**TYPE III APPLICATION
STAFF REPORT AND RECOMMENDATION**

December 7, 2015

FILE NUMBERS: CP 15-01: Concept (Master) Plan Amendment
DP 15-01: Detailed Development Plan
NR 15-05: Natural Resources Overlay District Review
US 15-06: Geologic Hazards Overlay District Review

REQUEST: The applicant submitted a Concept (Master) Plan Amendment, Detailed Development Plan, Natural Resource Overlay District Review and a Geologic Hazards Overlay District Review request for construction of Phase 1 of the Cove development.

Figure 12: Building Elevations

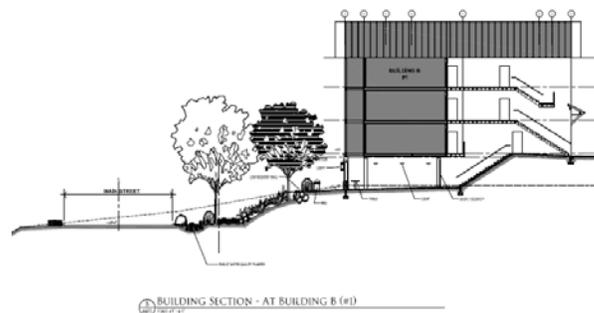
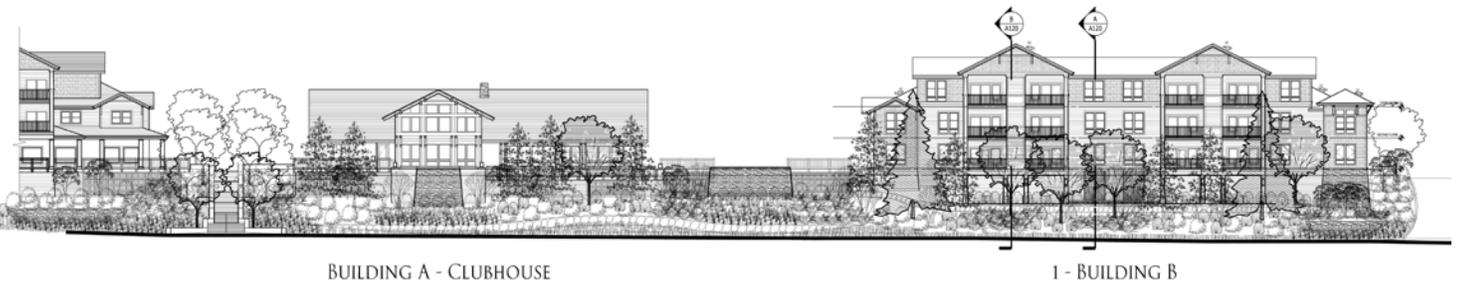
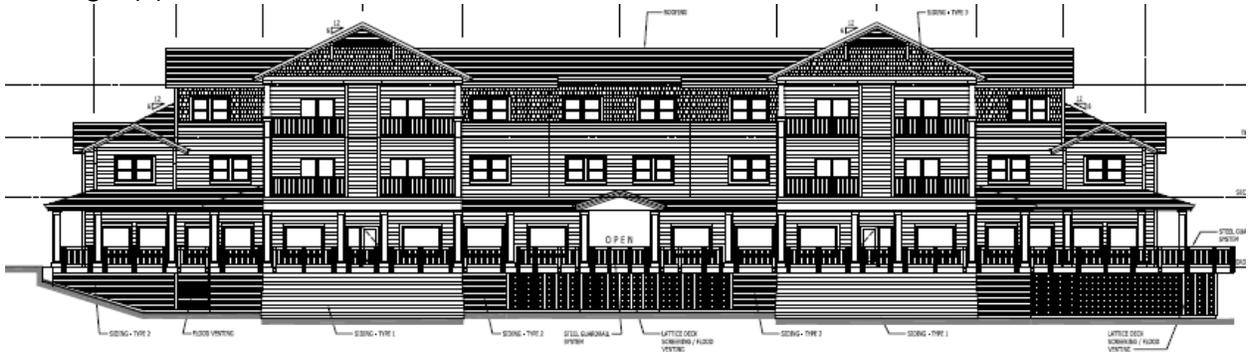
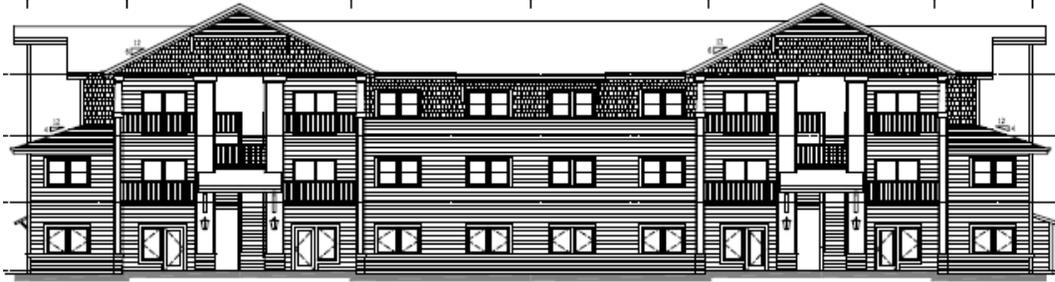
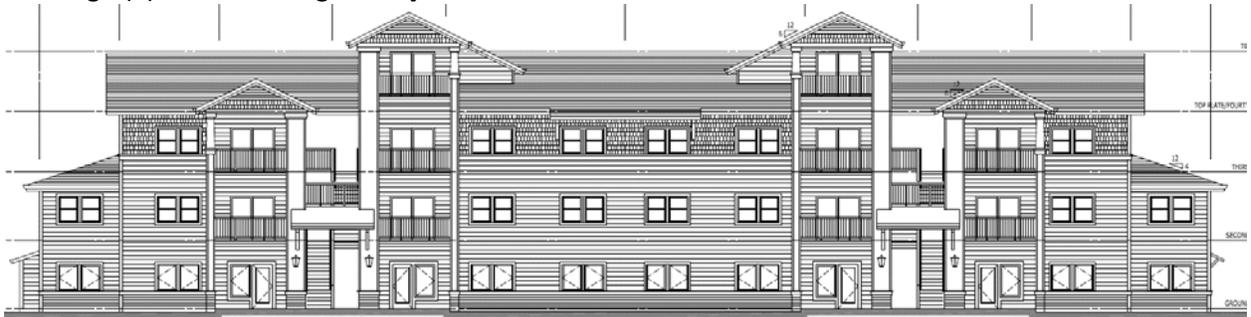
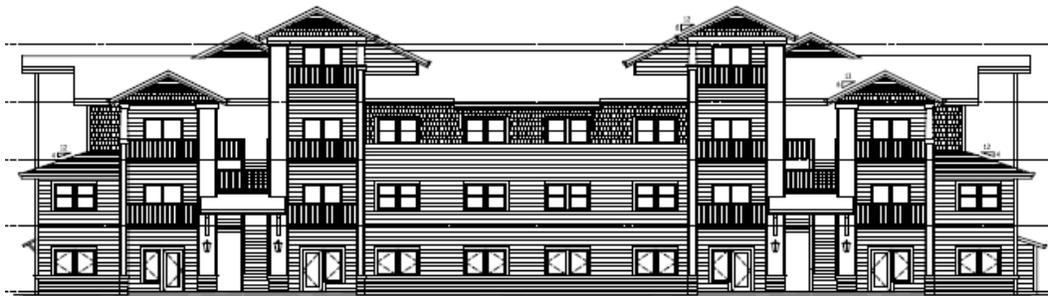
- a. Revised architectural plans for Buildings 3(D) and 5(F) which include double doors within each of the commercial spaces on the Main Street frontage. (P)

- b. Revised architectural plans in which the Main Street façade of Buildings A, D and F comply with OCMC 17.62.055.I.1 (60% transparency). (P)
 - c. Revised architectural plans in which the right façade of Building A complies with OCMC 17.62.055.I.1 (30% transparency). (P)

- d. Revised plans for the following facades which comply with OCMC 17.62.057.G.1 (building articulation and modulation). (P)
 - i. Front, rear, left and right façades of buildings C and J

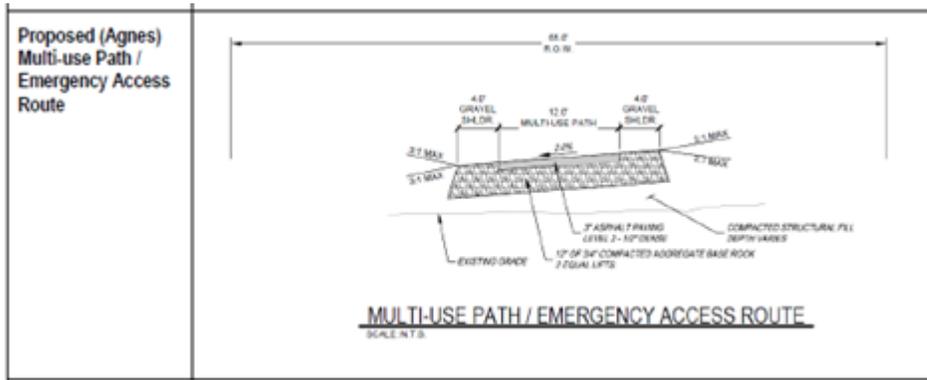
The City has reviewed the modification request. The applicant’s materials have many conflicts and discrepancies. It is not clear in particular what street sections are currently proposed. For instance, in the narrative, as a response to Condition of Approval #6 of CP 09-02, the applicant states that the full section of Agnes Avenue will be constructed from North Park to Washington Street. In Section 12.04.007 the applicant states that the section will consist only of a 12-foot paved path, with no justification of the proposed modification. The cross-sections shown on Sheet 2.0 of the Site Circulation Plan indicates a 12-foot paved path, while the plan view on the same sheet shows a sidewalk along one side of the path. Since it is unclear which of the numerous versions of street sections are actually being proposed, the reviewers had difficulty presenting the information in a comparative format between the prior proposals and approvals and the current proposal. We therefore offer our determination in the following format regarding street segments that are appropriate and necessary to serve the proposed development:

27. Southward from the roundabout, Main Street crown cross-section shall consist of (as measured beginning from right-of-way line) 0.5-foot public access strip, 6-foot sidewalk, 6.5-foot planter, 0.5-foot curb, 34-foot pavement, 0.5-foot curb, 6.5-foot planter, 6-foot sidewalk, 0.5-foot public access strip; to be constructed with Phase 1. Width of the planter strip and sidewalk may be reduced to accommodate topographic constraints, if approved by City Engineer at construction plan review. (DS)

28. Westward from the roundabout, Main Street shed cross-section shall consist of (as measured beginning from right-of-way line) 0.5-foot public access strip, 8-foot sidewalk, 4.5-foot planter, 0.5-foot curb, 34-foot pavement, 0.5-foot curb, variable width water quality planter or swale, 6-

foot sidewalk, 0.5-foot public access strip. Sidewalk shall not be required on the south side of between the esplanade and the northern entrance of Garden Apartments. Phase 1 shall construct southside sidewalk from northern entrance to Firestone Alley (McLoughlin Boulevard) Planter strip, swale and sidewalk may be reduced or eliminated along portions of the street where necessary to accommodate topographic constraints, if approved by City Engineer at construction plan review. (DS)
